Access Compliance Report

Public Rights-of-Way

(Pedestrian Signals)

Intersection ID: N/A	Main Street:	Cross Street: N/A	Location: N/A
ADA ID: ACE42C48F44C	Signal Type: Two Push Buttons-APS	Overall Compliance: No	Severity Score: BTN 1:N/A BTN 2: N/A No BTN: N/A
Codes/Mitigation Info/Possible Solution		Field Measurements/Component Compliance

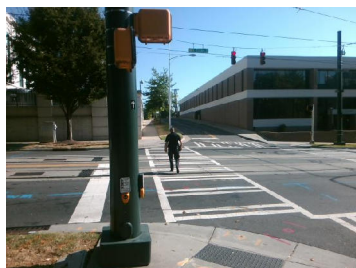
PROW/ADA: R209.1, TMUTCD 4e.08, R404.2, R404.3, R104.2, , R406.2

Compliance	Description	Data	Compliance	Description	Data
	Button Count	Button2	N/A	Distant to Additional Button (in)	N/A
	Additional Button Present?	N/A		Additional Button ID	N/A
N/A	Signal Buttons Required?	N/A	N/A	Additional Ped Posts Required	N/A
	How Many Ped Street Xings?	2		Located In An Island/Median?	No
N/A	B 1 Sign Present?	Yes	N/A	B 2 Sign Present?	Yes
No	B 1 Sign Purpose?	No	Yes	B 2 Sign Purpose?	Yes
Yes	B 1 Sign Lettering & Contrast?	Yes	Yes	B 2 Sign Lettering & Contrast?	Yes
Yes	B 1 Parallel To XWalk?	Yes	Yes	B 2 Parallel To XWalk?	Yes
Yes	B 1 PAR to Button?	Yes	Yes	B 2 PAR to Button?	Yes
Yes	B 1 PAR to XWalk?	Yes	Yes	B 2 PAR to XWalk?	Yes
Yes	B 1 Clear Floor Space?	Yes	Yes	B 2 Clear Floor Space?	Yes
N/A	B 1 FWD Approach?	Yes	N/A	B 2 FWD Approach?	Yes
N/A	B 1 FWD Approach Constrained?	No	N/A	B 2 FWD Approach Constrained?	No
Yes	B 1 FWD Approach Reach (in)	0.0	No	B 2 FWD Approach Reach (in)	26.0

N/A	B 1 FWD Approach Width (in)	N/A	N/A	B 2 FWD Approach Width (in)	N/A
N/A	B 1 FWD Approach Obstruction?	No	N/A	B 2 FWD Approach Obstruction?	No
N/A	B 1 FWD Approach Obstruction Dist (in)	N/A	N/A	B 2 FWD Approach ObstructionDist (in)	N/A
N/A	B 1 PARA Approach?	Yes	N/A	B 2 PARA Approach?	Yes
N/A	B 1 PARA Approach Constrained?	No	N/A	B 2 PARA Approach Constrained?	No
Yes	B 1 PARA Approach Reach (in)	0.0	Yes	B 2 PARA Approach Reach (in)	0.0
N/A	B 1 PARA Approach Width (in)	N/A	N/A	B 2 PARA Approach Width (in)	N/A
N/A	B 1 PARA Approach Obstruction?	No	N/A	B 2 PARA Approach Obstruction?	No
N/A	B 1 PARA Approach Obstruction Dist (in)	N/A	N/A	B 2 PARA Approach ObstructionDist (in)	N/A
No	B 1 Clear Floor Space Slope (%)	4.6	No	B 2 Clear Floor Space Slope (%)	6.4
Yes	B 1 Clear Floor Space XSlope (%)	0.1	Yes	B 2 Clear Floor Space XSlope (%)	0.1
N/A	B 1 PAR Slope (%)	2.0	N/A	B 2 PAR Slope (%)	1.4
Yes	B 1 Height (in)	35.0	Yes	B 2 Height (in)	36.0

Yes	B 1 Pressure (#)	2.0	Yes	B 2 Pressure (#)	2.0
No	B 1 Closed Fist Operation?	No	No	B 2 Closed Fist Operation?	No

Yes	B 1 Clear Xing Direction?	ClearlyMarked	Yes	B 2 Clear Xing Direction?	ClearlyMarked
	B 1 Crossing Direction	To SE		B 2 Crossing Direction	To NE
Yes	B 1 DistanceTo XWalk (in)	0.0	Yes	B 2 DistanceTo XWalk (in)	20.0
No	B 1 DistanceTo Curb (in)	90.0	Yes	B 2 DistanceTo Curb (in)	32.0
Yes	B 1 Diameter (in)	2.0	Yes	B 2 Diameter (in)	2.0

Possible Solutions: Replace Signal Push Button With APS Button on New Post.
Remove & Replace Sign. Remove & Replace Replace APS Button With New APS Button.
Remove and Replace Clear Space.
